Subject: **ABENGOA MOJAVE SOLAR 09-AFC-5**

ENERGY COMMISSION STAFF'S ERRATA TO THE SUPPLEMENTAL STAFF ASSESSMENT PART B – BIOLOGICAL RESOURCES SECTION

BIOLOGICAL RESOURCES - FIGURE 1

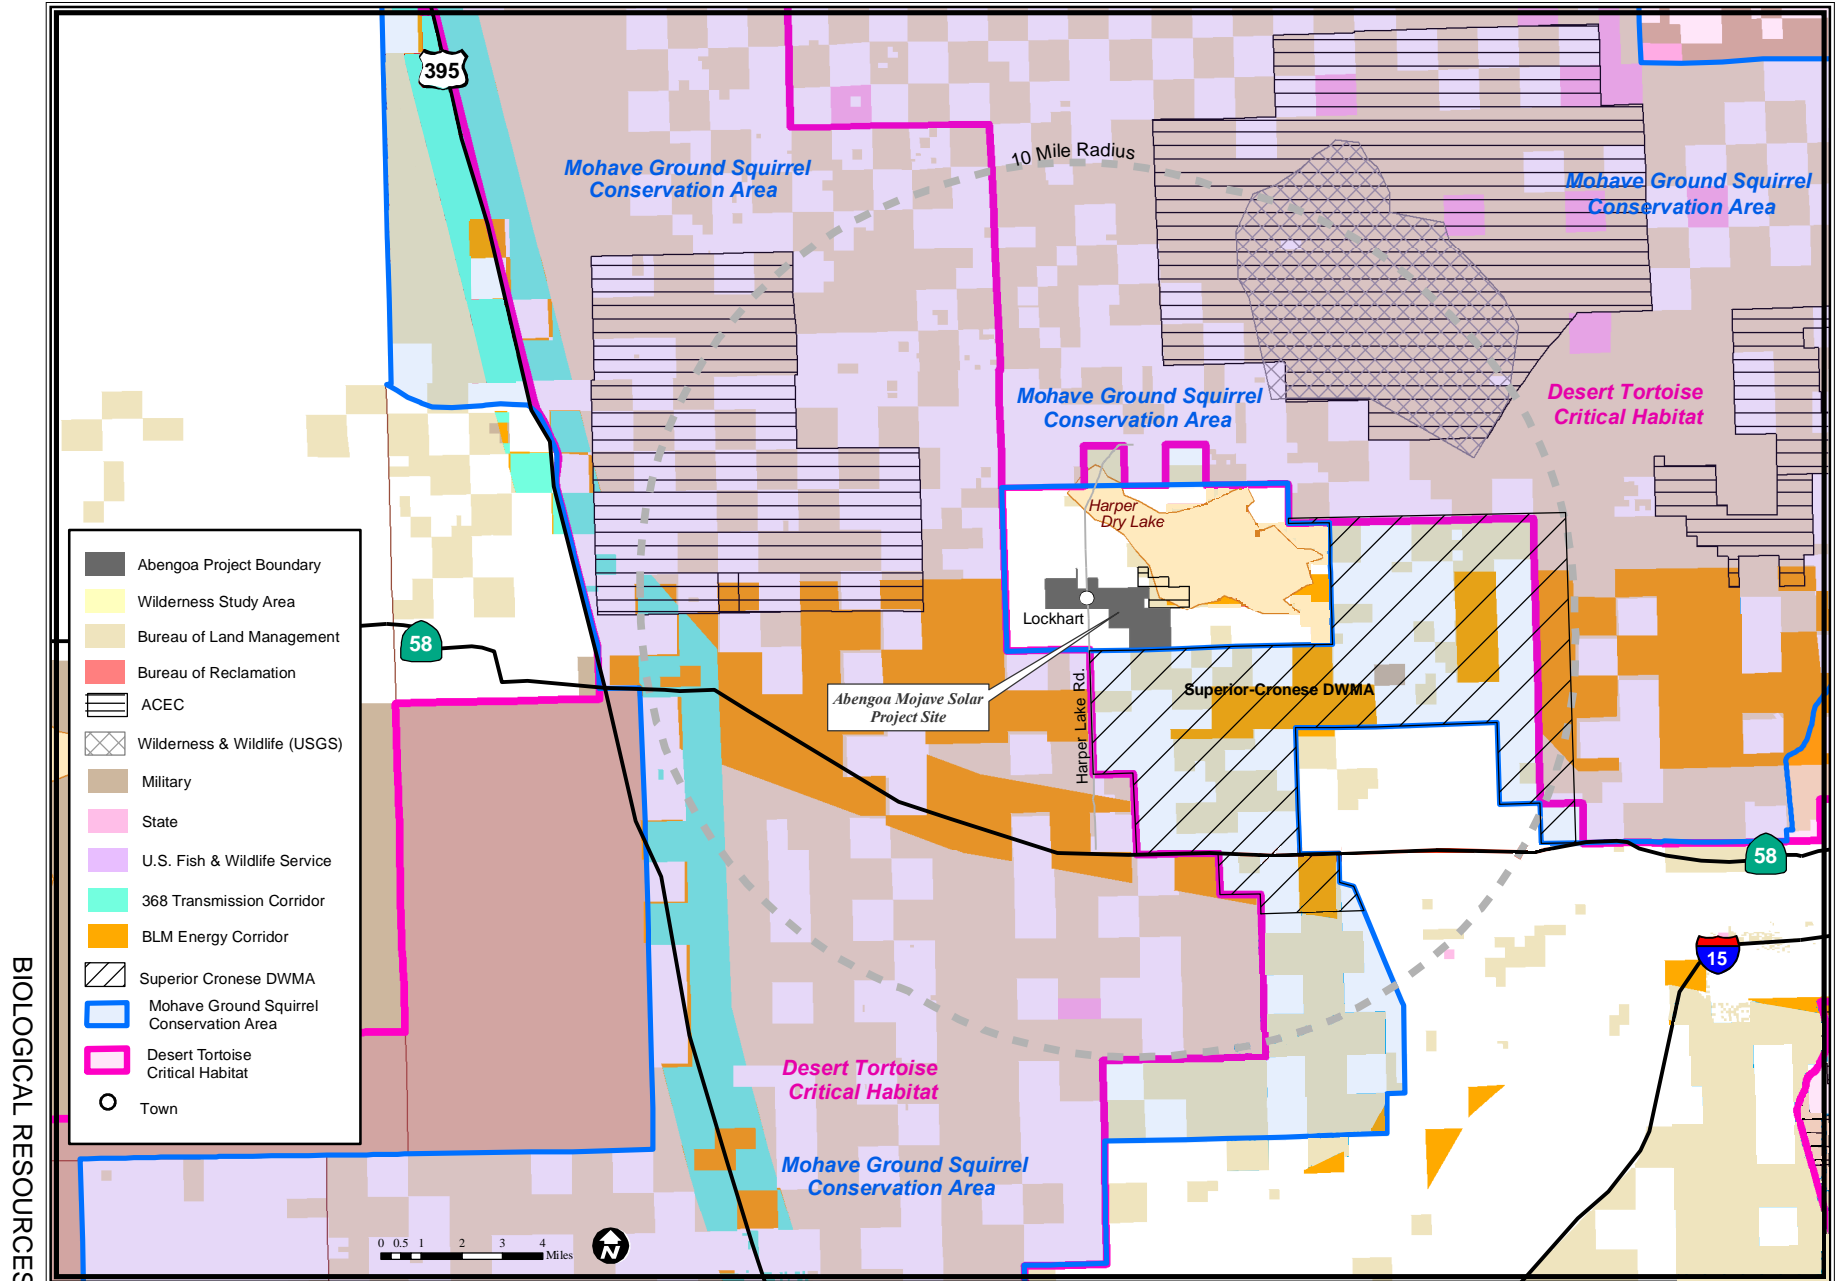
Energy Commission staff is providing an Errata to the Biological Resources section of the Supplemental Staff Assessment Part B. The attached Biological Figures 1 and 2 are intended to replace what is included in Supplemental Staff Assessment Part B. The attached figures were previously included in the Staff Assessment dated March 15, 2010 and should have been in the Supplemental Staff Assessment Part B.
